Access Compliance Report

Public Rights-of-Way

Intersection ID: 14294	Main Street: EAST_BV	Cross Street: EUCLID_AV	Location: SW
ADA ID: FC6DAC924547	Ramp Type: Directional1	Initial Pass/Fail: Fail	Overall Compliance: No
		Severity Score: 60

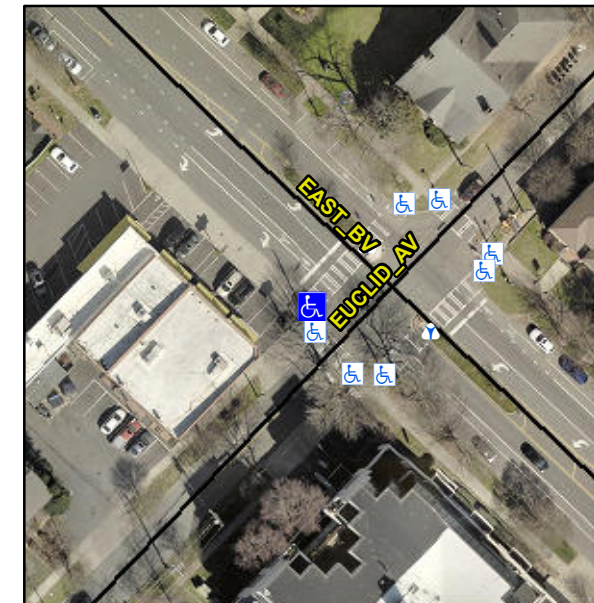
R304.5.1, R304.2.2, R304.5.3

Compliance	Description	Data	Compliance	Description	Data
N/A	Ramp Length (in)	56.0	N/A	Grade Break?	N/A
No	Ramp Width (in)	30.0	N/A	Grade Break Slope (%)	0.0
No	Ramp Slope (%)	9.0	N/A	Grade Break XSlope (%)	0.0
No	Ramp XSlope (%)	5.8			
N/A	Flare Type LT	N/A	N/A	Flare Type RT	N/A
N/A	Flare Slope LT (%)	N/A	N/A	Flare Slope RT (%)	0.0
N/A	Flare Traversable LT?	N/A	N/A	Flare Traversable RT?	N/A
N/A	Landing Length (in)	0.0	N/A	DWS Provided?	N/A
N/A	Landing Width (in)	0.0	N/A	DWS Contrast?	N/A
N/A	Landing Slope (%)	0.0	N/A	DWS Length (in)	N/A
N/A	Landing X Slope (%)	0.0	N/A	DWS Full Width?	N/A
N/A	Landing Curb? (Y/N)	N/A	N/A	DWS Offset LT (in)	N/A
N/A	Shared Landing?	N/A	N/A	DWS Offset RT (in)	N/A
N/A	Gutter Ponding?	0.0	N/A	Gutter Slope (%)	N/A
N/A	Gutter Lip Ht (in)	0.0	N/A	Gutter X Slope (%)	N/A
N/A	Painted X Walk1?	Yes		Road Slope (%)	9.0
	X Walk 1 Direction	To NE		Road X Slope (%)	0.2
	X Walk 1 Width (in)	113.0		Clear Space?	N/A

X Walk 1 Slope (%)	9.0	N/A	Clear Space to XWalk (in)	N/A
	X Walk 1 X Slope (%)	0.2	N/A	Storm Grate/Utility Hazard?	N/A
N/A	Ramp inside XWalk1?	Yes		Storm Grate/Utility Type	
N/A	Any Obstructions?	N/A			N/A
	Obstruction Type		Yes	Surface Condition? (G/P)	Good
			N/A	Curb Slope (%)	2.9

Remove & Replace Entire Ramp.
